ADDENDUM NO. 3

**RE: NCDAC NC Correctional Institution for Women
Air Conditioning Installation
SCO ID#: 22-24913-02A
NCDAC Central Engineering Job Order # 4290**

DATE: September 12, 2023

1 AIRFLOW BALANCE TABLE FOR SINGLE CELL B

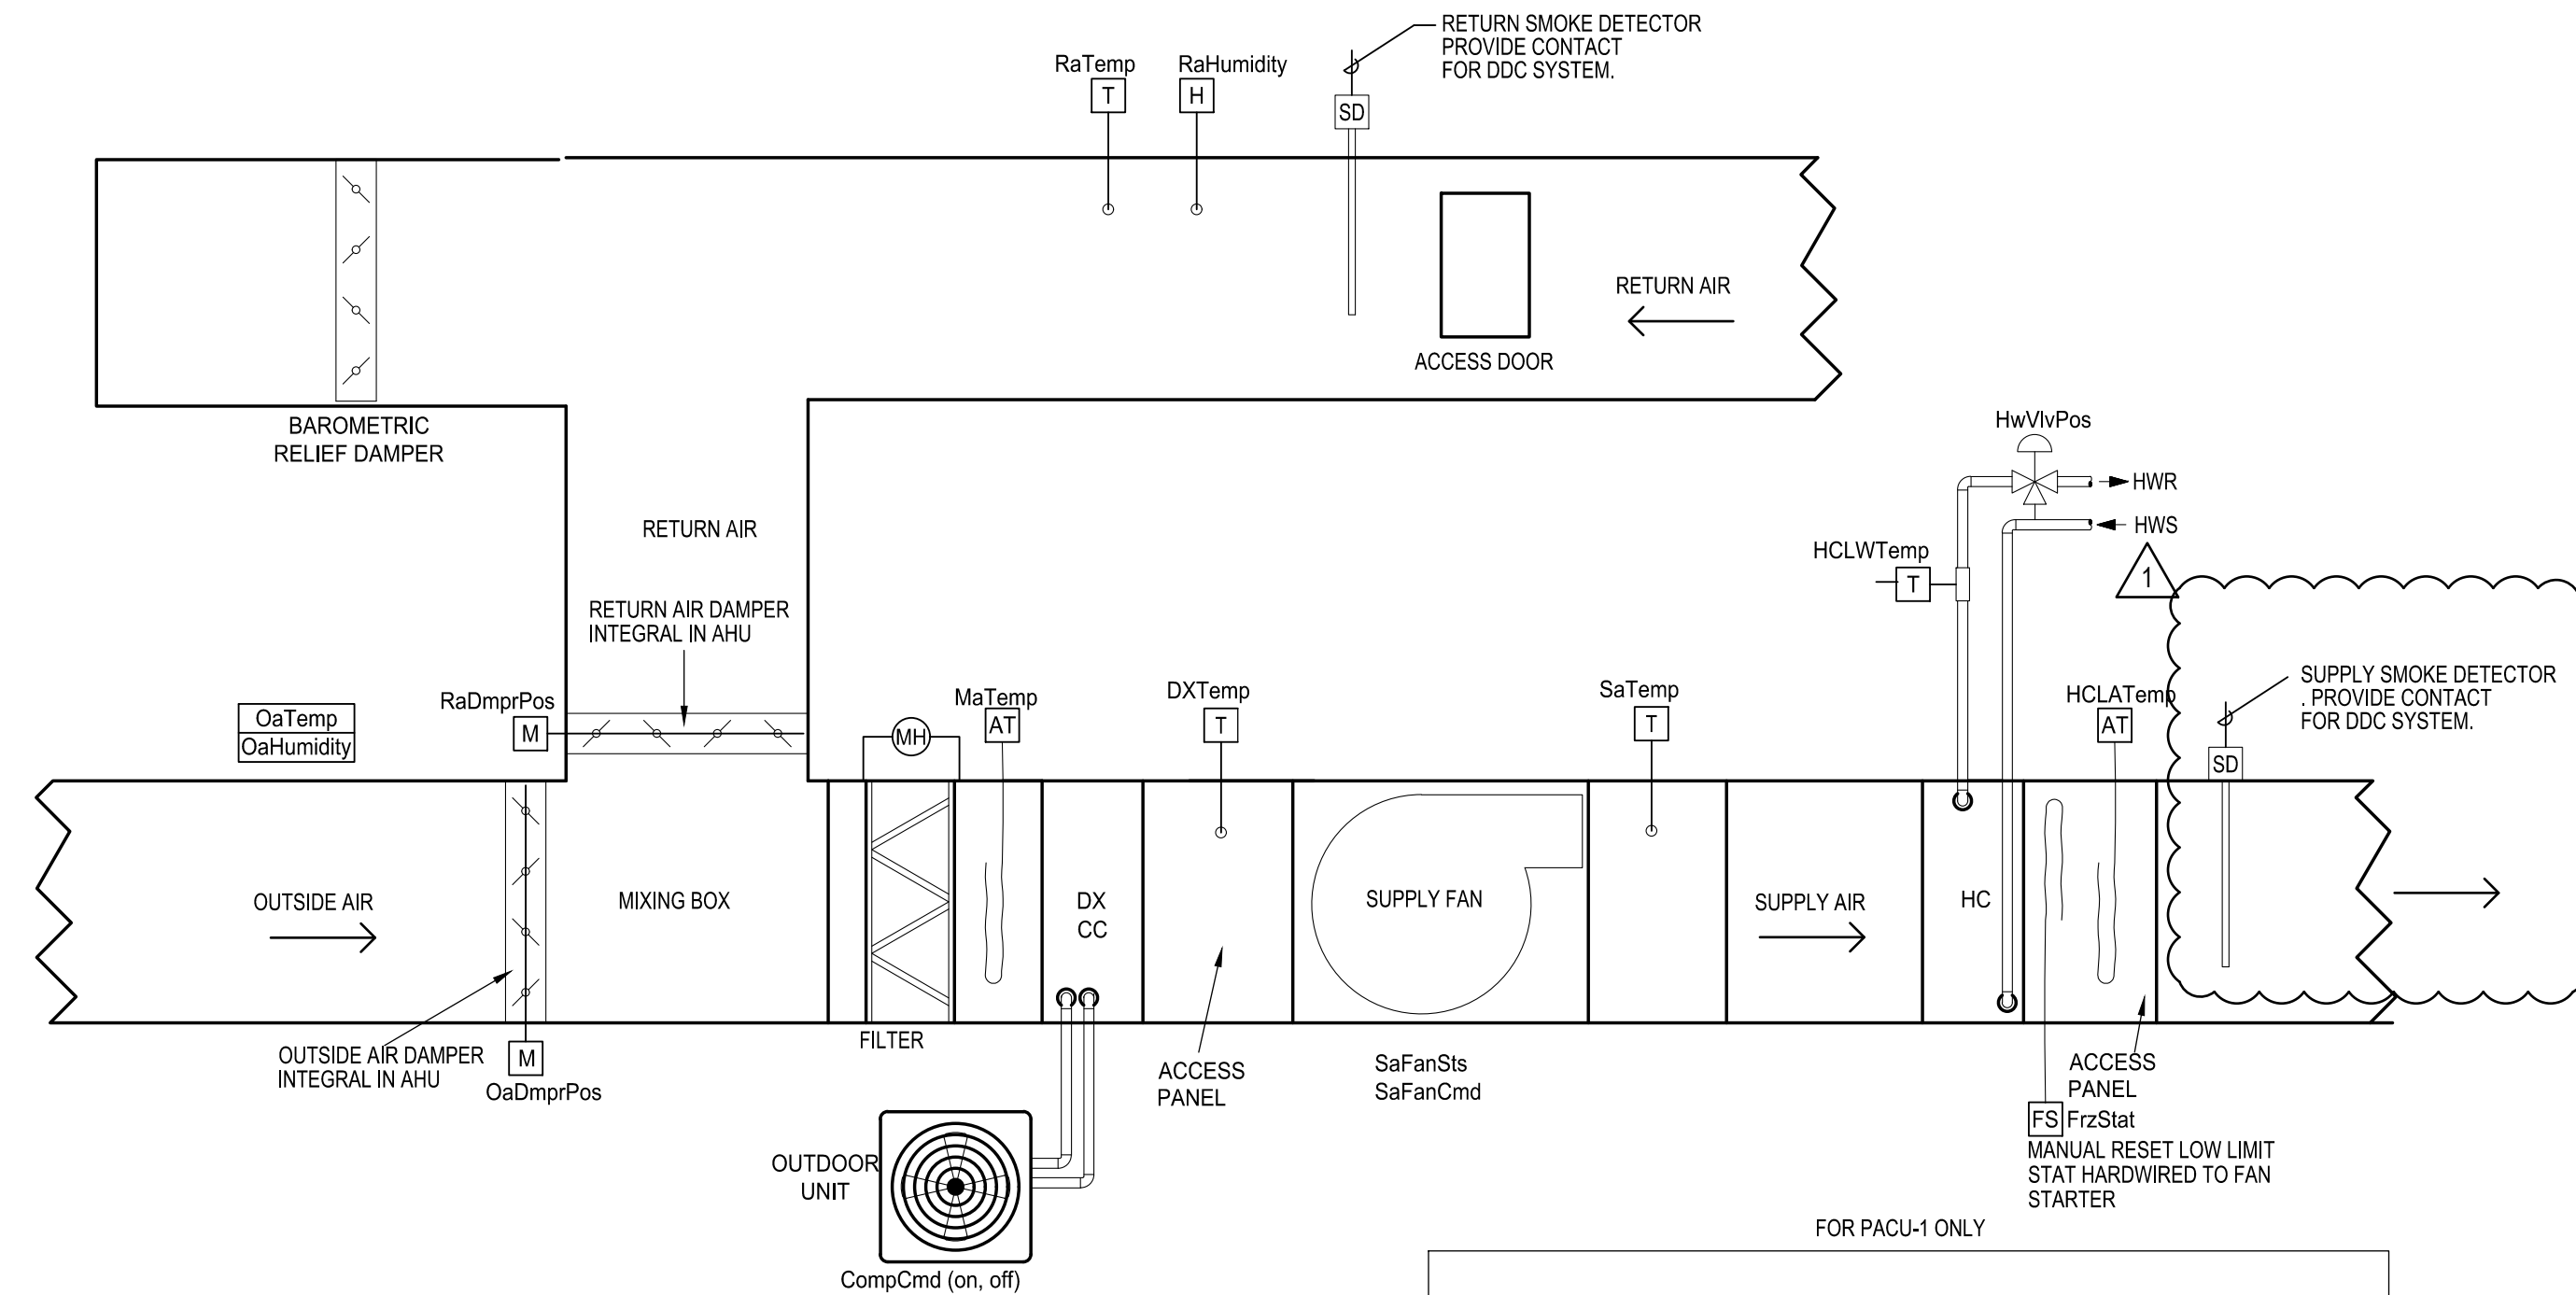
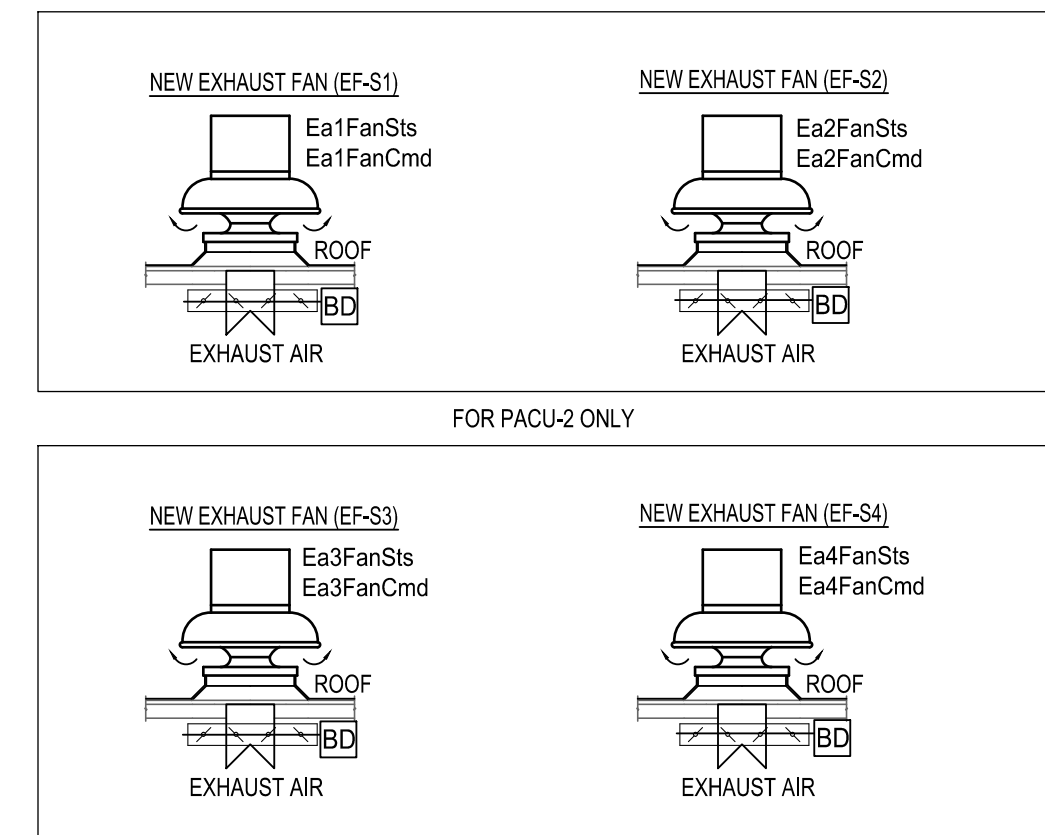
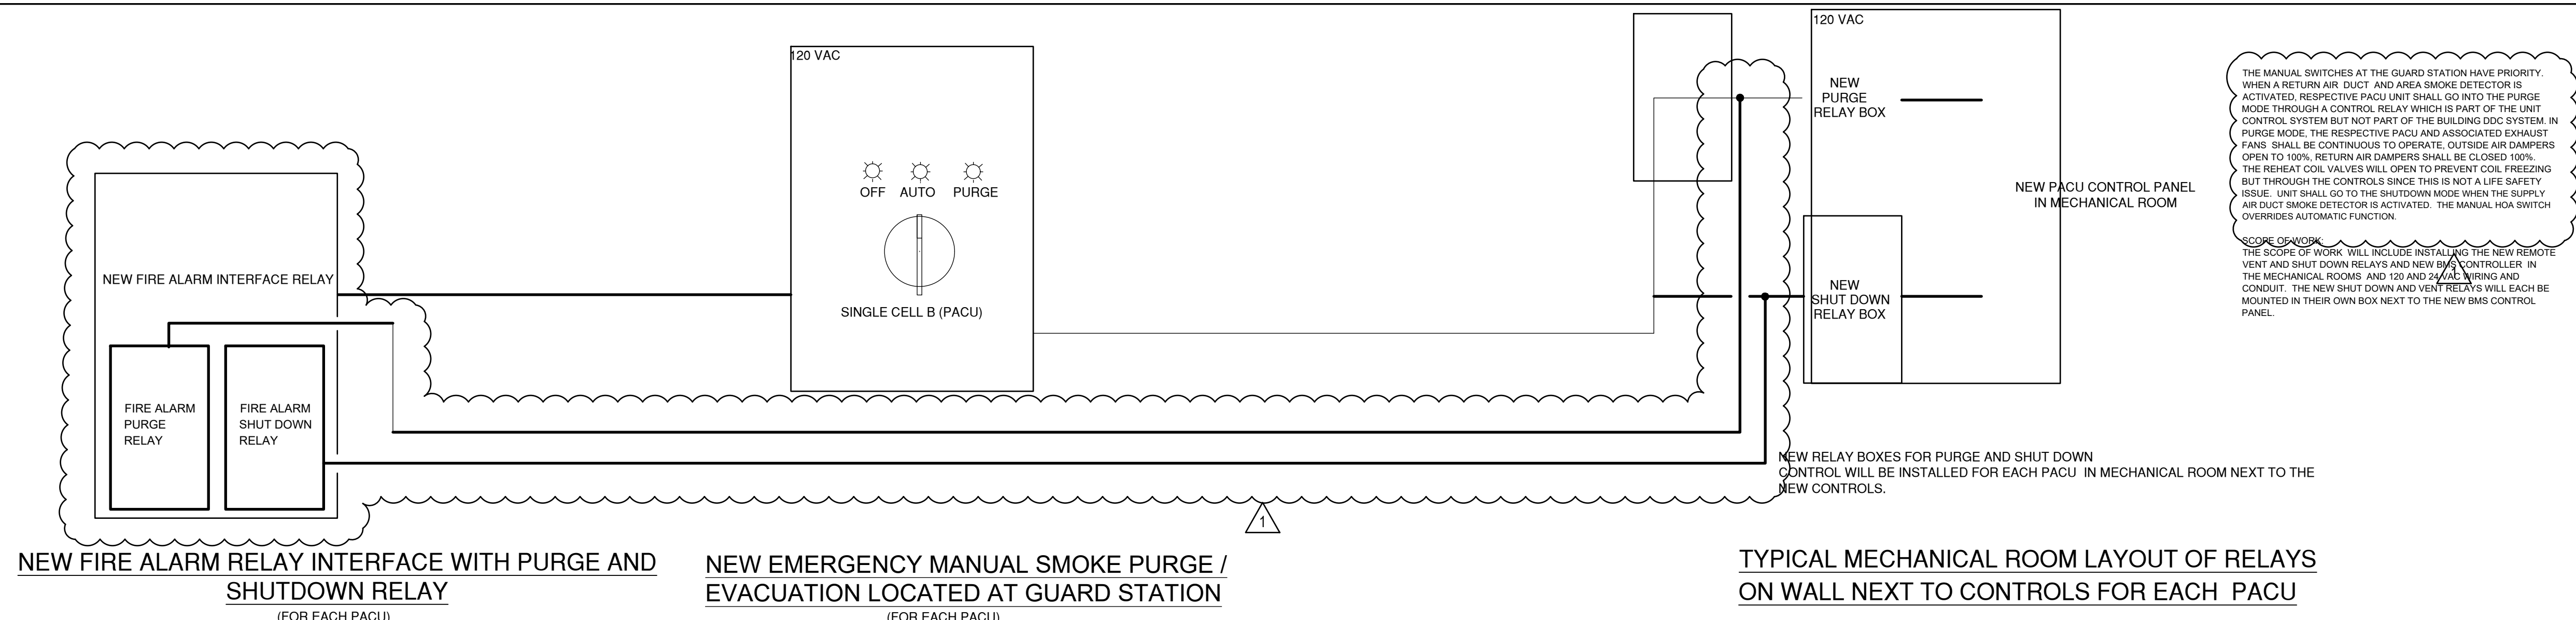
14. Sheet M605: See revisions on attached sheet.
15. Sheet M607: See revisions on attached sheet.
16. Sheet M608: Revise sequence of operation. See revisions on attached sheet.
